**Ohio Field Office  
Fernald Closure Project  
175 Tri-County Parkway  
Springdale, Ohio 45246  
(513) 648-3155**

DOE-0024-06

**IMPLEMENTATION OF CONTINGENCY ACTIONS FOR SILO 3**

**DCN 40430-JEG-287. HVAC MODIFICATION**

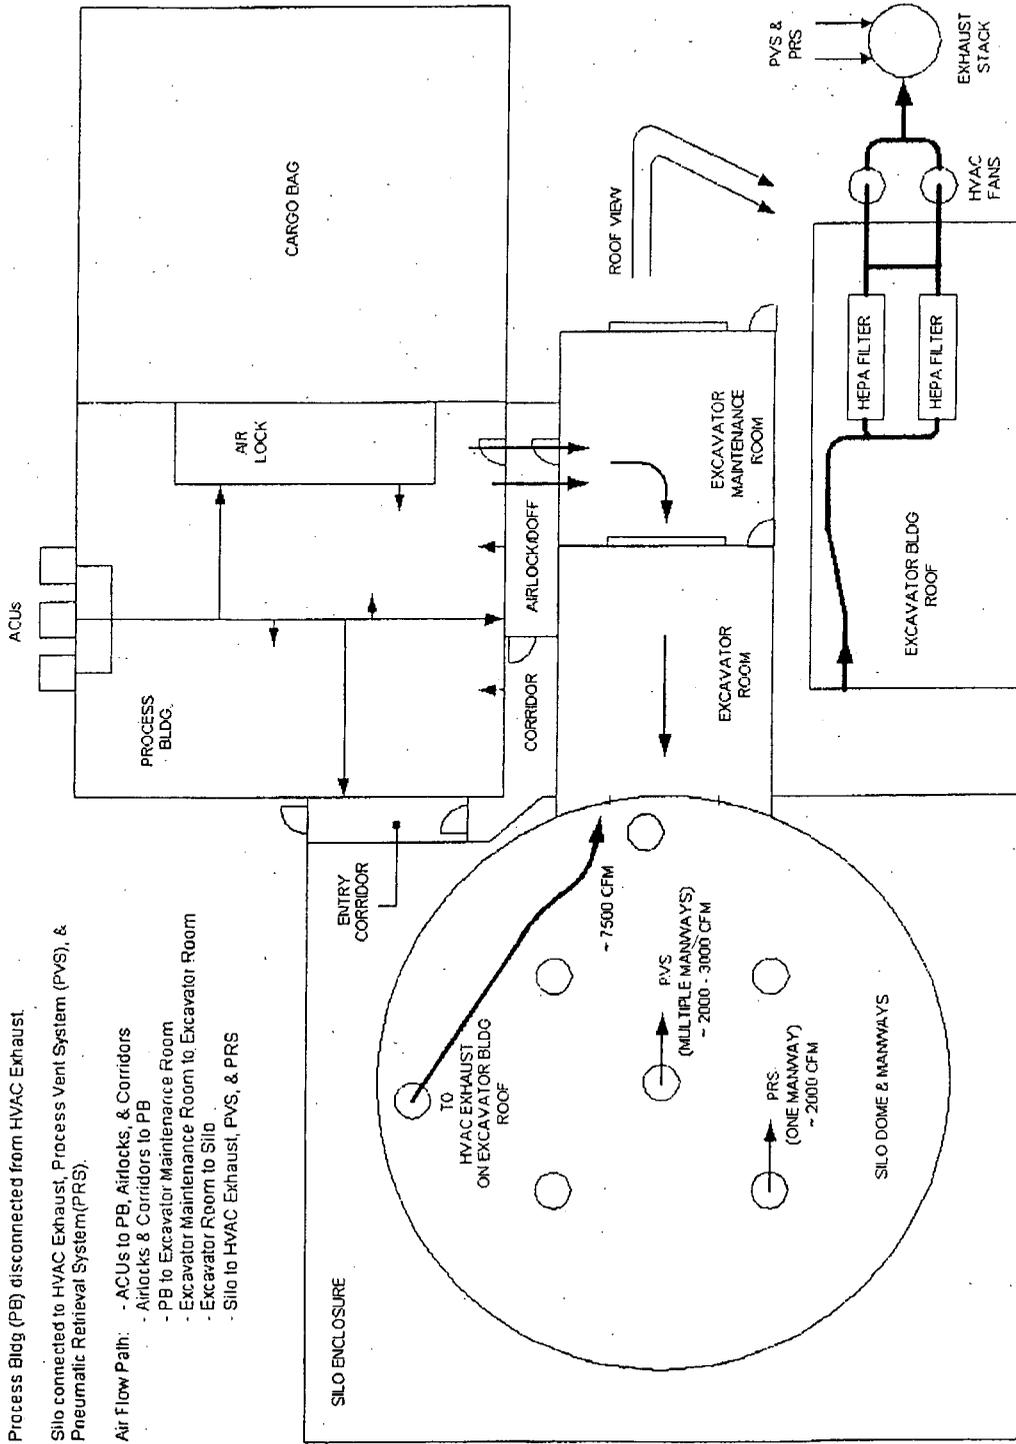
2. No liquid additive solution will be added to the material.
3. As already documented in Design Change Notice (DCN) 40430-JEG-287, the Ventilation flow in the Silo 3 remediation Facility has been reconfigured to maximize airflow from the excavator maintenance room through the excavator room, into Silo 3 and thereby maximize containment of airborne emissions during mechanical retrieval and direct loading (see Enclosure 2).

Process Bldg (PB) disconnected from HVAC Exhaust.

Silo connected to HVAC Exhaust, Process Vent System (PVS), & Pneumatic Retrieval System (PRS).

- Air Flow Path:**
- ACUs to PB, Airlocks, & Corridors
  - Airlocks & Corridors to PB
  - PB to Excavator Maintenance Room
  - Excavator Maintenance Room to Excavator Room
  - Excavator Room to Silo
  - Silo to HVAC Exhaust, PVS, & PRS
